Re: Third Submission Review – Nick’s Convenience – Jackson Gap at Porteos – Site Plan and Plat
Application Number: **DA-1903-35**
Case Numbers: **2023-6040-00, 2023-3038-00**

Third Submission Review

SITE PLAN - NICK'S CONVENIENCE

UTILITY PLAN
 NICK'S CONVENIENCE
 25500 E. 64th AVENUE
 AURORA, COLORADO

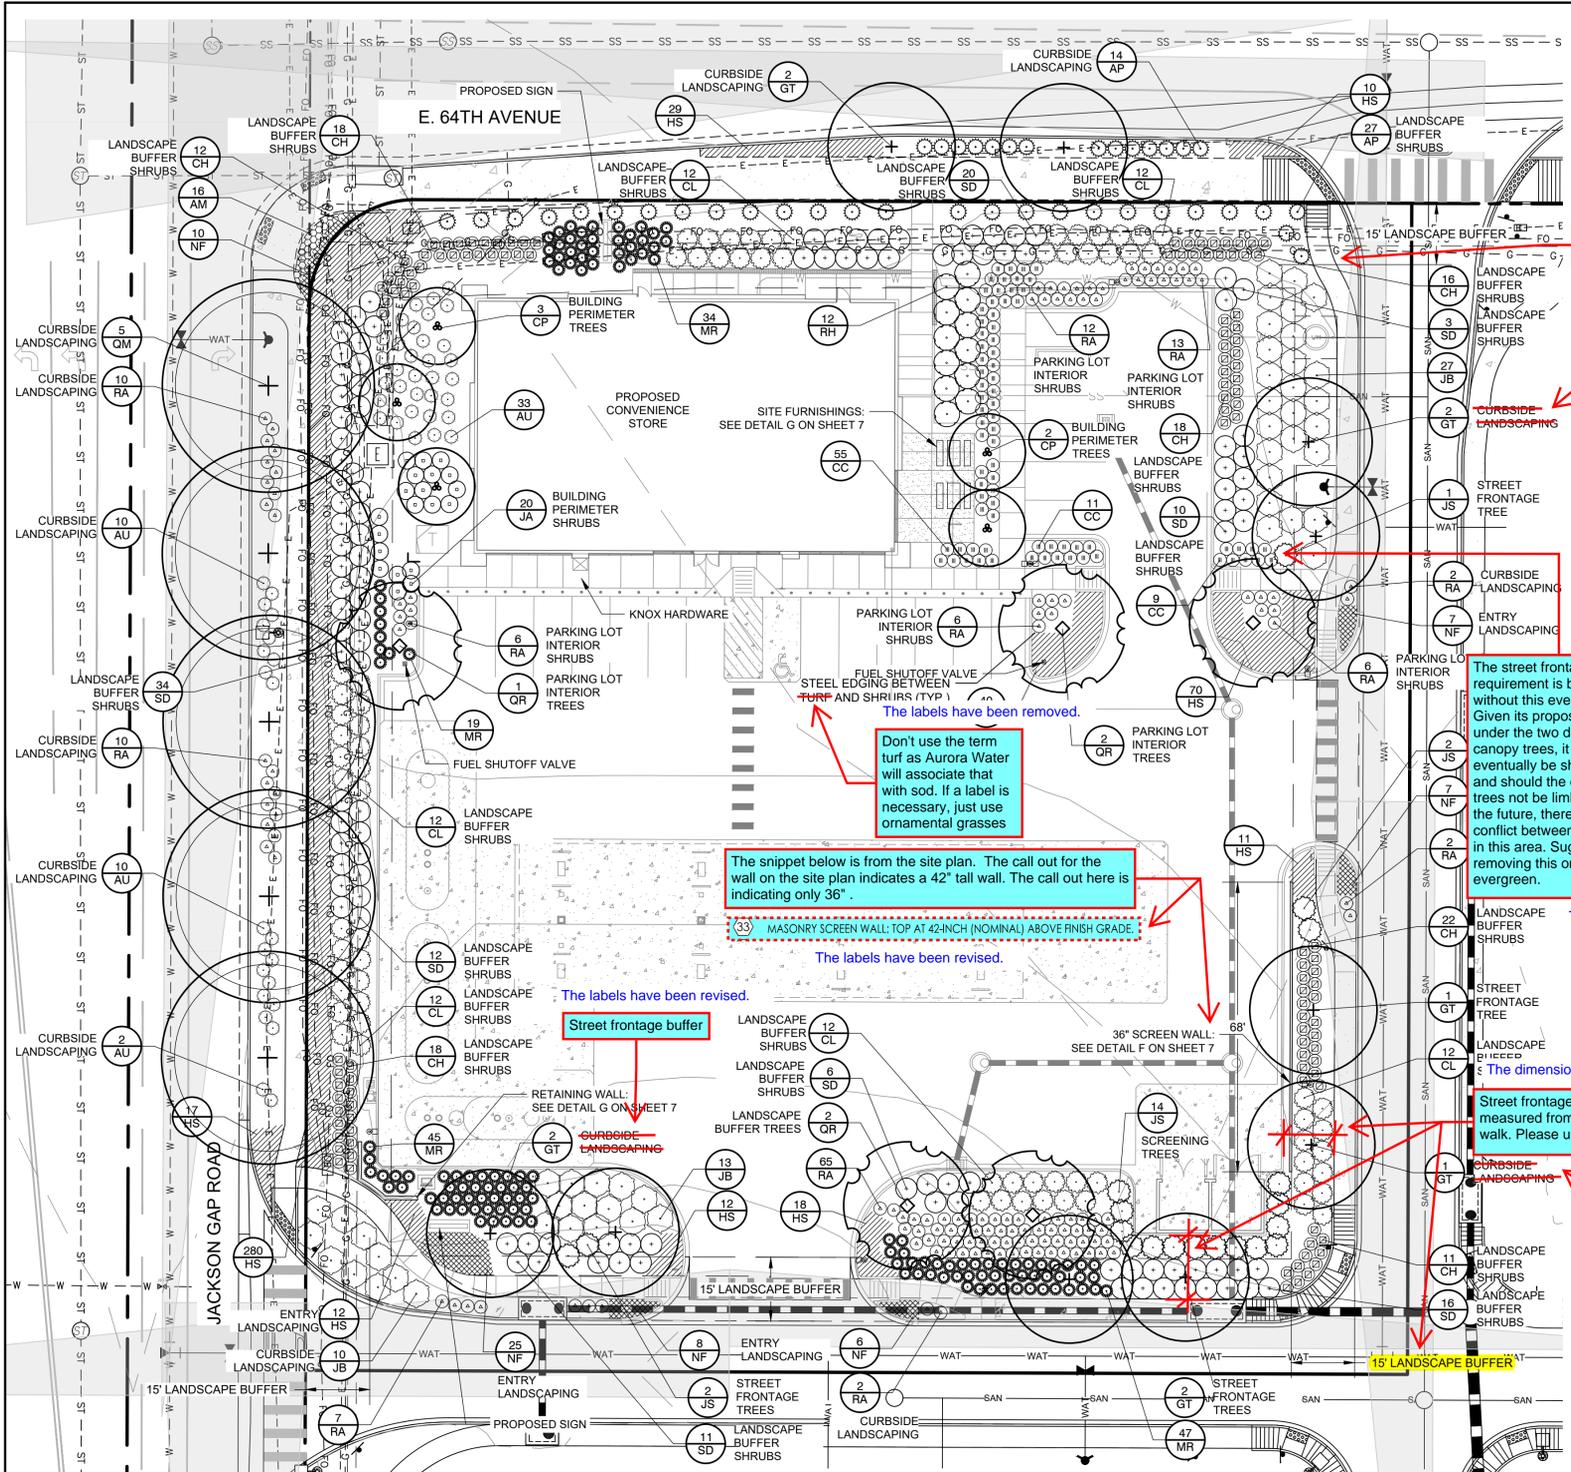
Match the plat when naming the easements.
 Revised Accordingly

Water
 Revised Accordingly

LANDSCAPE NOTES
 NICK'S CONVENIENCE
 xxxxxx E. 64th AVENUE
 AURORA, COLORADO

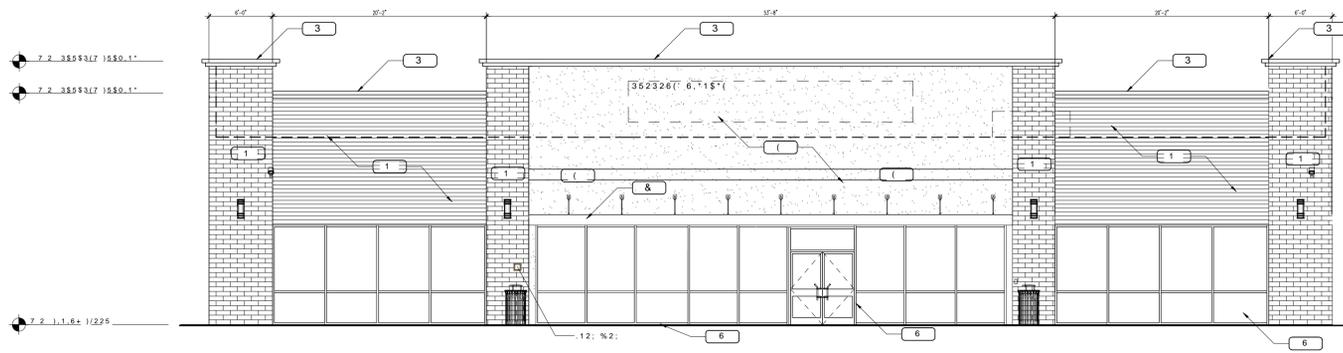
Remove contractor notes as the city Planning Department does not review landscape construction drawings. Please do include a note regarding the mulch treatment.

Remove the reference to the previous landscape code.

The notes have been revised.

The text has been revised.

The revisions have been completed as requested. However, if curbside landscaping is not required for these property lines, the comments appear to be requiring the project to provide twice the street frontage planting requested by the code. Street frontage requirements were already met in a separate calculation.

A PARCEL OF LAND SITUATED IN THE NW 1/4 OF SECTION 8, T.3S., R.65W. OF THE 6TH P.M.
CITY OF AURORA, COUNTY OF ADAMS, STATE OF COLORADO
SHEET 1 OF 2

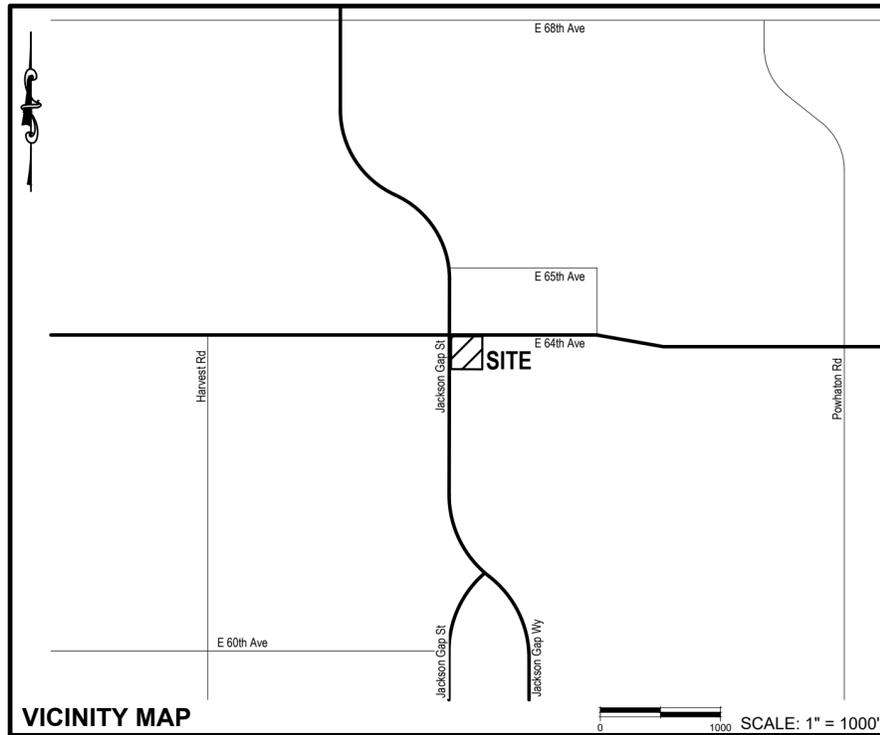
(Advisory Comment) Send in the updated Title Commitment to be dated within 30 calendar days of the plat approval date. (This Commitment should be submitted at the time of your final submittal of the electronic Plat for recording.)

(Advisory Comment) Send in the Certificate of Taxes Due show they are paid in full up to and through the plat approval date of recording. Obtained from the County Treasurer's office. (This Certificate of Taxes should be submitted at the time of your final submittal of the electronic Plat for recording.)

(Advisory Comment) Be advised - sometimes the margins or scale factor may not match the County or City standards as stated in the Subdivision Plat Checklist. If any of these factors are misaligned or scale does not match the drawing information, then this may cause the plat to be sent back and corrected and thus adding time to your submittal. And in turn, you may need to update the Title Commitment to bring it within the 30-day time limit. Please check these items before sending the plat in for recording.

update to the new Title Commitment date - see Advisory Comment

Comment Noted - Updated Title Commitment to be provided prior to final submittal and recordation

Comment Noted - Certificate of Taxes Due will be provided prior to recordation

Comment Noted

Comment Noted - Date for the updated Title Commitment to be provided prior to final submittal and recordation

A PARCEL OF LAND SITUATED IN THE NW 1/4 OF SECTION 8, T.3S., R.65W. OF THE 6TH P.M.
CITY OF AURORA, COUNTY OF ADAMS, STATE OF COLORADO
SHEET 2 OF 2

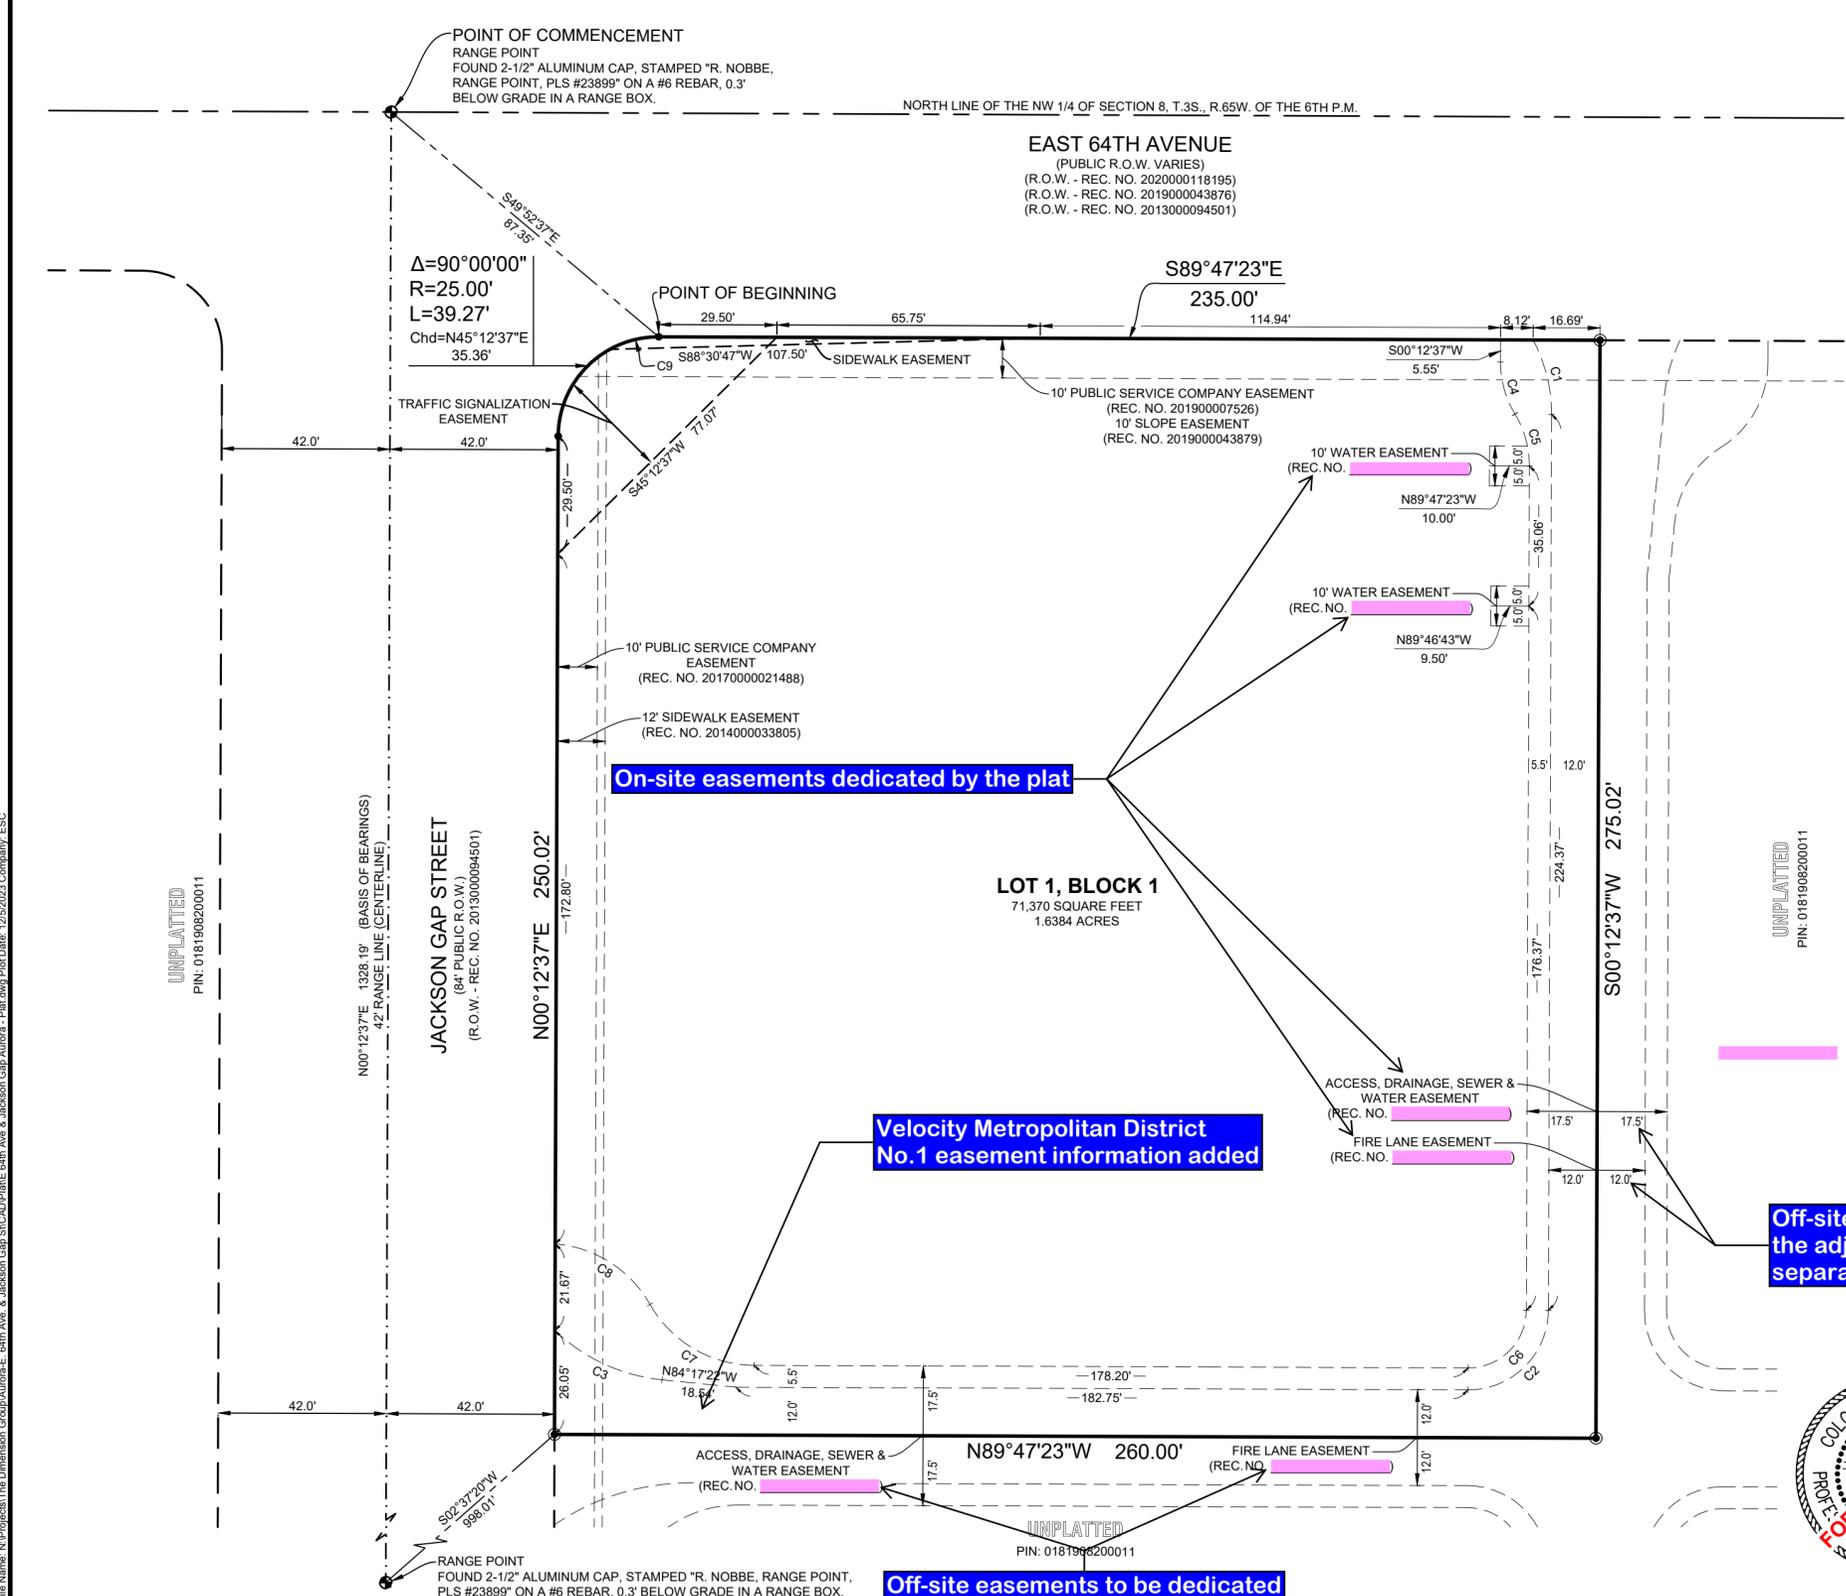
14E. Fill in the recording number blanks.

Comment noted. Please be advised that the plat has been revised to reflect the existing Velocity Metropolitan District No. 1 easements, as well as the municipal easements that are to be dedicated via the plat. Off-site easements have been identified that are to be dedicated by the adjacent property owner, by separate document.

On-site easements dedicated by the plat

Velocity Metropolitan District No. 1 easement information added
